**Response to NRC Request for Additional Information on
WCAP-17057-P, Revision 0, "GSI-191 Fuel Assembly Test Report for PWROG"**

February 2010

This document provides responses to requests for additional information [1] related to WCAP-17057-P, Revision 0.

Figure 1-1: Microtherm – Individual Particle

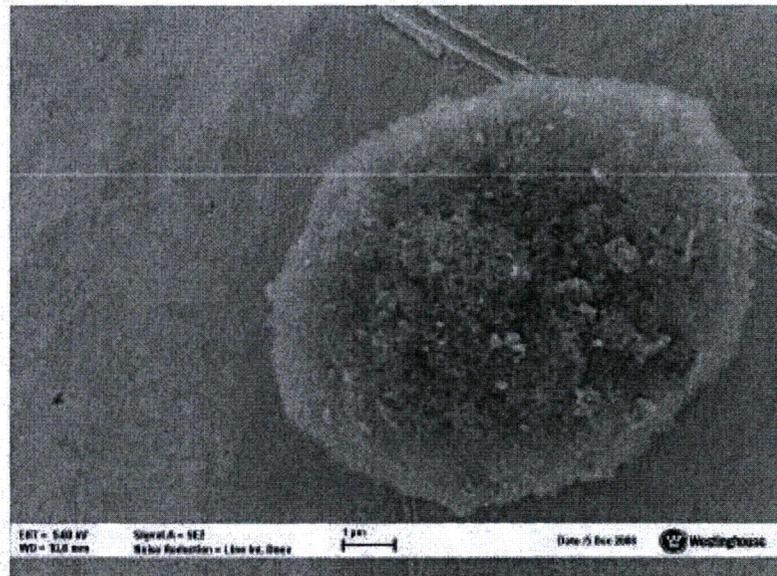
Page 7-2, Table 7-2 lists a maximum microporous insulation debris load of 3.2 lbm while the maximum quantity tested was 1.47 lbm: Please discuss why a 2.2x factor above the tested amount is acceptable for microporous insulation.

Microporous insulation does have a fibrous content which is removed when the microporous insulation passes through the sump screen. The preparation of the microporous material for fuel assembly tests simulated this process. The microporous insulation Microtherm was obtained from Microtherm, Inc. The material was supplied in a pulverized form. It was passed through a #7 sieve with a hole size of 0.11". The sieving is necessary to obtain test material that is representative of Microtherm that would pass through the sump screen. Then the material was characterized by scanning electron microscopy. An individual particle of microporous silica is shown in Figure 1-1. A lower magnification image showing multiple Microtherm particles is displayed in Figure 1-2. The processed Microtherm material appeared to be almost completely devoid of fibers suggesting that they had been removed by the screening process and is essentially a particulate.
